# UNITED STATES PATENT AND TRADEMARK OFFICE

APPLICATION NO.	FILING DATE	FIRST NAMED INVENTOR	ATTORNEY DOCKET NO.	CONFIRMATION NO.
10/632,017	07/31/2003	Olaf Abels	71084	9343
23872	7590	12/07/2005		
MCGLEW & TUTTLE, PC P.O. BOX 9227 SCARBOROUGH STATION SCARBOROUGH, NY 10510-9227			EXAMINER GARCIA, ERNESTO	
			ART UNIT 3679	PAPER NUMBER

<b>Office Action Summary</b>	<b>Application No.</b>	<b>Applicant(s)</b>	
	10/632,017	ABELS ET AL.	
	<b>Examiner</b>	<b>Art Unit</b>	
	Ernesto Garcia	3679

JP2-199317, Yao

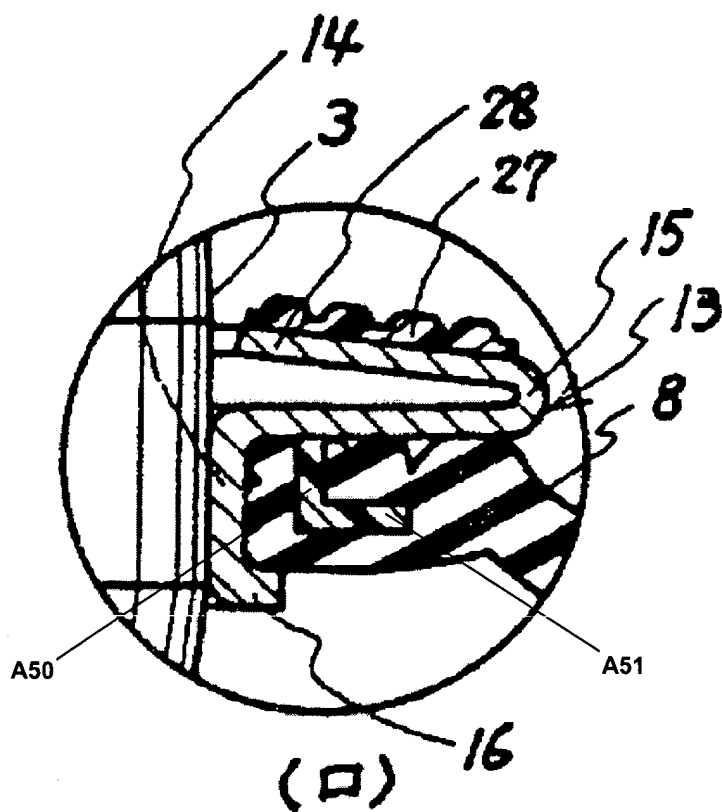
Regarding claim 1, Yao, discloses, in Figures 1, 3 and 4, a ball-and-socket joint comprising a housing **6**, a bearing shell **5**, a ball pivot **2**, a sealing bellows **8**, a ball race **13**, and a sliding ring **A1**. The bearing shell **5** is inserted into the housing **6**. The ball pivot **2** with a joint ball **4** is pivotally mounted in all directions in the bearing shell **5**. The sealing bellows **8** is between the housing **6** and the ball pivot **2**. The sealing bellows **8** has a pivot-side edge area **23**. The ball race **13** is fixed on the ball pivot **2**. The sliding ring **A1** receives the pivot-side edge area **23** of the sealing bellows **8**. The sliding ring **A1** is mounted to slide in the ball race **13** and has a sliding face **A9** facing the joint ball **4** arranged adjacent to the ball race **13**. The ball race **13** has a leg **15** in contact with the sliding ring **A1**. The leg **15** comprising lugs **28** (Fig. 4) arranged at spaced locations from one another.

Regarding claim 5, the sliding ring **A1** includes an axial extension **14** and a radial extension **16**.

Regarding claim 9, the ball race **13** has an approximately U-shaped cross section.

Regarding claim 10, the sealing bellows **8** has a surface **A100** slidably in contact with a surface **A20** of the ball race **13**.

Regarding claim 12, the surface **A100** of the sealing bellows **8** forms a labyrinth seal together with the surface **A20** of the ball race **13**.

Regarding claim 14, the sliding ring **A1** is a shaped sheet metal part or a plastic molding. The sliding ring **A1** receives and holds a portion of the sealing bellows **8** between the axial extension **14** and the radial extension **16**. The axial extension **14** and the radial extension **16** are substantially perpendicular to each other. The ball race **13** is fixed to the ball pivot **2**.

Regarding claim 17, the pivot-side edge area **23** of the sealing bellows **8** forms a thickened material bead pressed against the ball race **13** or the sliding ring **A1** with an elastic pretension.

Regarding claim 20, the sliding ring **A1** has an approximately L-shaped cross section.

Regarding claim 23, the sliding ring **A1** is vulcanized directly to the pivot-side edge area **23** of the sealing bellows **8**.

Regarding claim 29, the lugs include free ends (the free ends are occupied by feature **27**; Fig. 3, or the free ends could be at the bent **15** in Fig. 4). The free ends face away from the ball pivot **2** in a radial direction (note that Figure 3 shows a free end does not face when free end is perpendicular to the ball pivot **2**, but when unassembled, the free end faces at an angle thus away). Alternatively, the bent at **15** also faces away from the ball pivot.

Regarding claim 30, the Japanese patent, as discussed above, discloses the sliding ring **A1** having an L-shaped cross section comprising an axial leg **A50** and a radial leg **A51**. However, the radial leg **A51** is not in sliding contact with an inner surface of the ball race **13**. Gardner teaches, in Figures 2 and 3, a radial leg **27** in sliding contact with an inner surface of a ball race **23**, as part of an alternative configuration of mounting a sealing bellows to a ball race. Therefore, as taught by Gardner, it would have been obvious to one of ordinary skill in the art at the time the invention was made to make the radial leg in sliding contact with an inner surface of the
